Re: Amended Proposal - Billyard Ave Developments Pty Ltd ATF Billyard Avenue Development Trust v The Council of the City of Sydney NSWLEC 2023/00440488

Property: 21C Billyard Avenue & 10 Onslow Avenue, Elizabeth Bay (Site)

Development Application No. D/2023/727 (DA)

**Combined Objection to a Development Application: D/2023/727 - Revised.
No.10, Onslow Avenue and No.21C, Billyard Avenue,
Elizabeth Bay - Residential Flat Building
Visual Impact Assessment Report: Revised Scheme, July 2024**

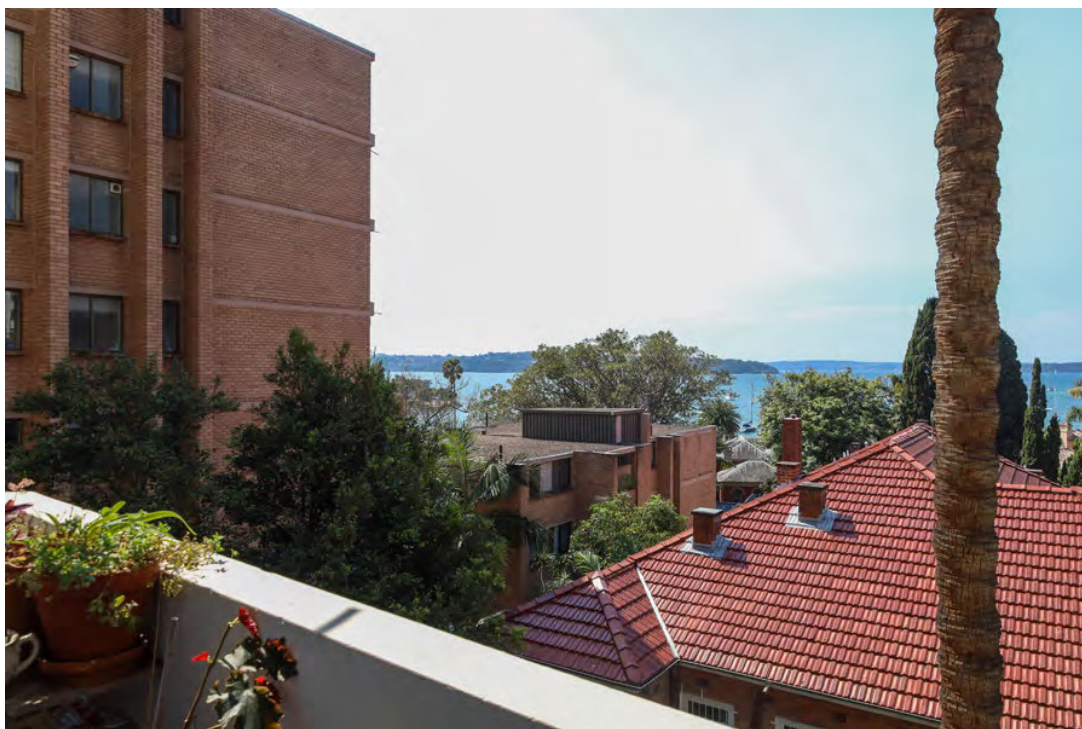
The revised development proposal, at No.10, Onslow Avenue and No.21C, Billyard Avenue, rises to a height that is above the permitted building envelope designated to this site. This height exceedance causes significant view loss to the entirety of the visible portion of the Athol Bay and Bradleys Head foreshore from this location, both being high value visual features. The upper levels of the new proposal also impact upon the Bradleys Head ridgeline beyond and a portion of the sky view above the existing building on the site.

When comparing the revised proposal to the previous submission, there is a small reduction in the visual impact at the upper level, of the lower building on the site, with a very small portion of the water and foreshore component of the view to the northeast retained, together with a minor increase in sky view above. The minor increase in view is not sufficiently significant to reassess the general value of view loss, since this is a very high-value existing view from this location.

Viewpoint no.07 - Unit 8

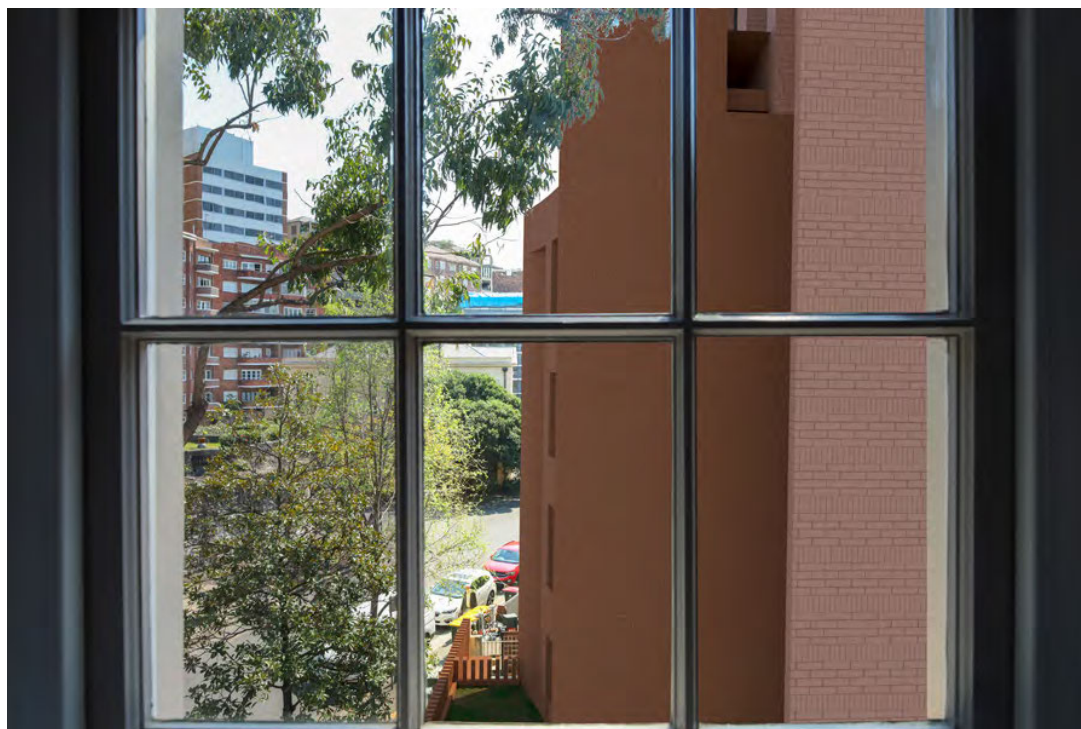
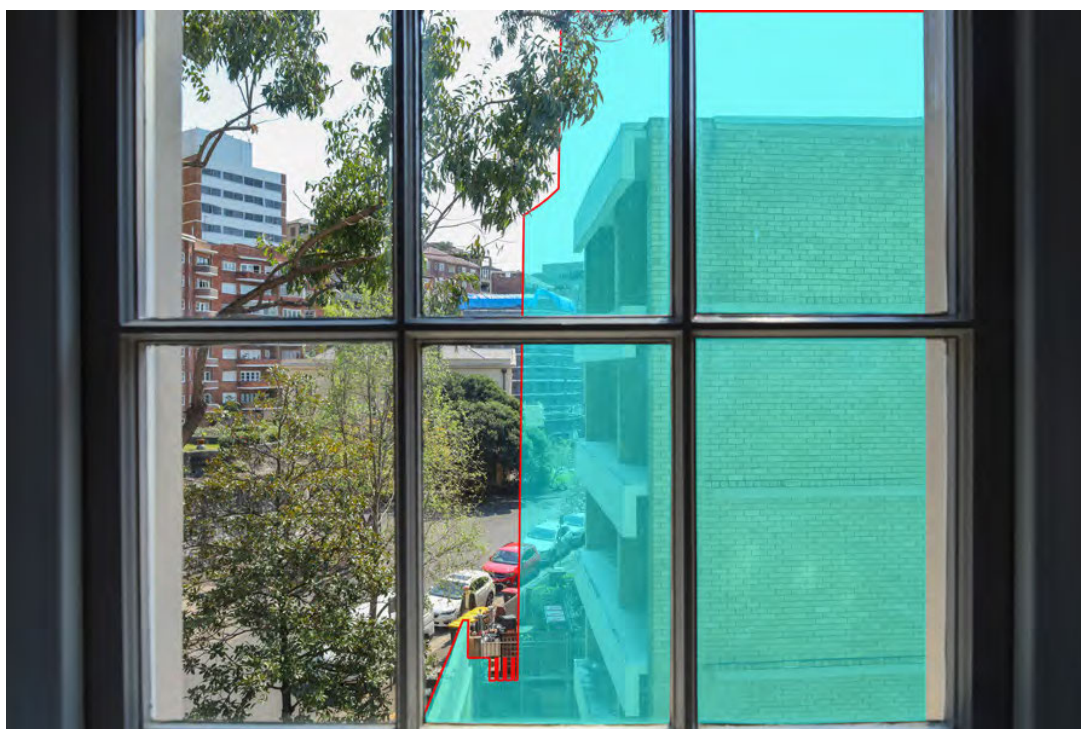
When comparing the revised proposal to the previous submission, there is a small reduction in the visual impact at the upper level, of the upper building on the site, as a result of the increased setback from the western site boundary. There is a small increase in the view towards Elizabeth Bay House, although sky view loss remains the same. There would be a small reduction in the view loss calculation as a result

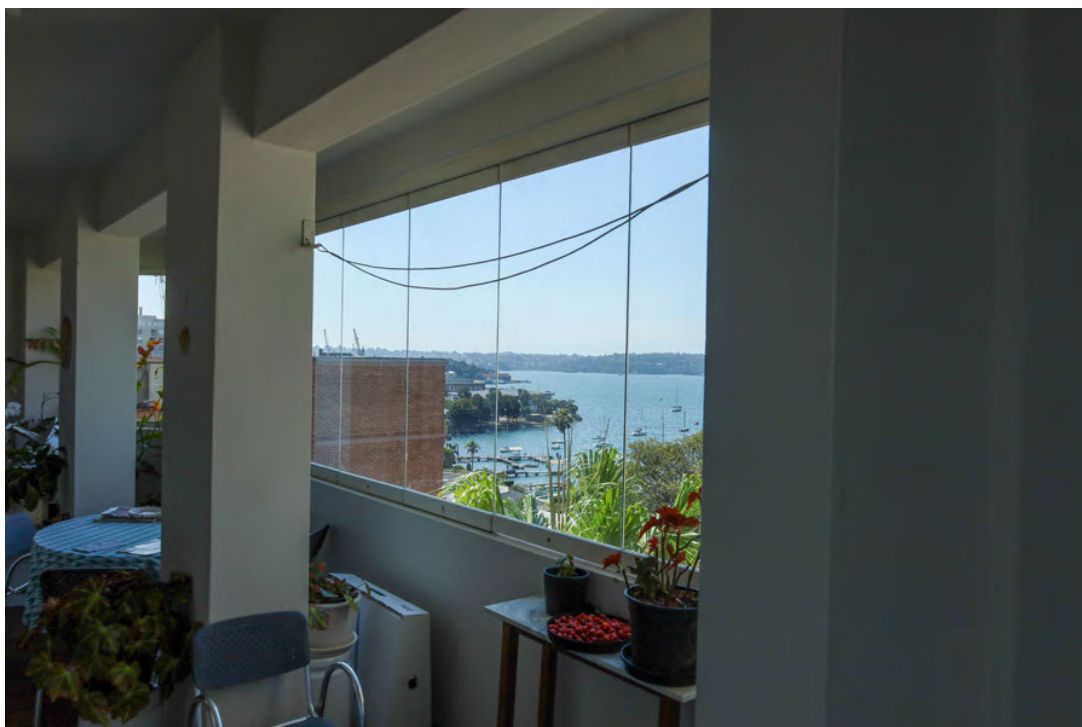
When comparing the revised proposal to the previous submission, there is a small reduction in the visual impact at the upper level, of the lower building on the site, which does not vary to any significant degree to the original visual impact.

Viewpoint no.11 - Unit 12

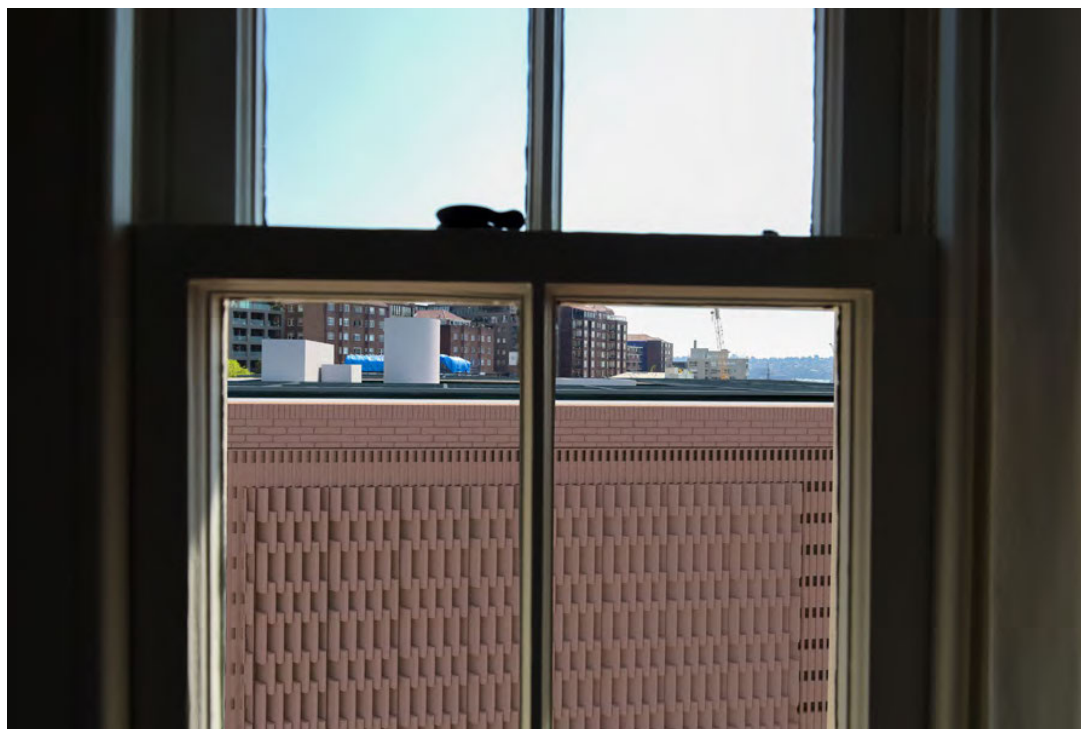
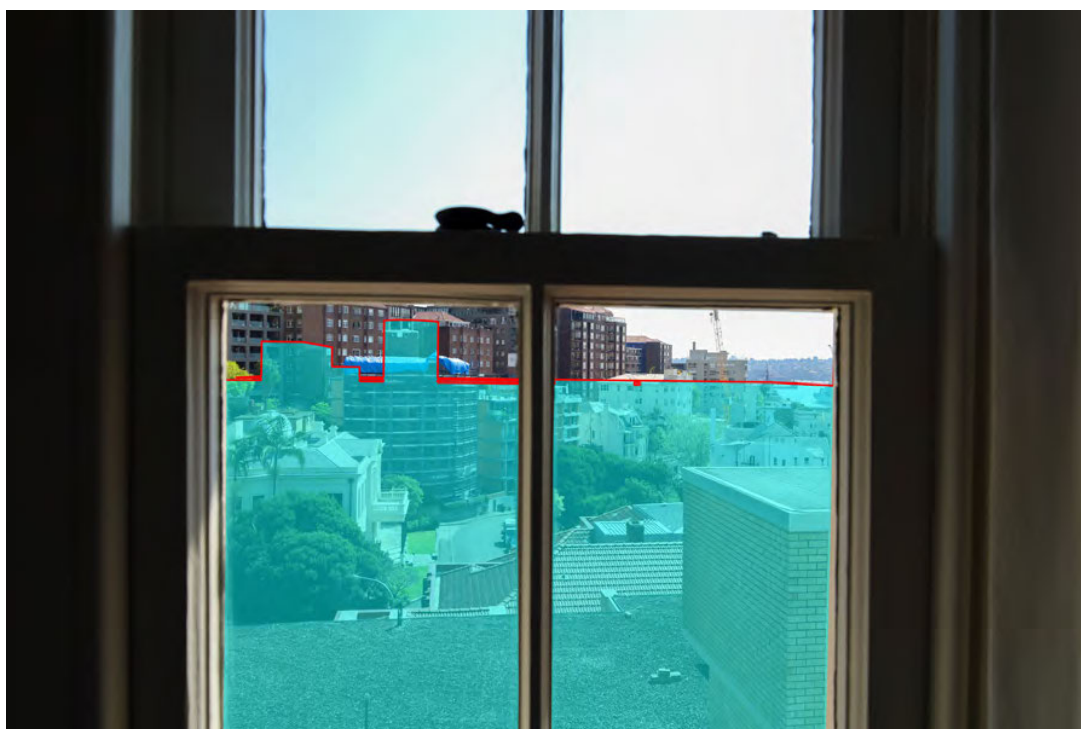
When comparing the revised proposal to the previous submission, there is a reduction in the visual impact at the upper level, of the upper building on the site, as a result of the increased setback of its top level built form. There is an increase to the amount of view available to the buildings along Billyard Avenue, although the entirety of Elizabeth Bay House is still impacted. The distant ridge line to the northwest becomes visible, although the water view remains concealed by the new design.
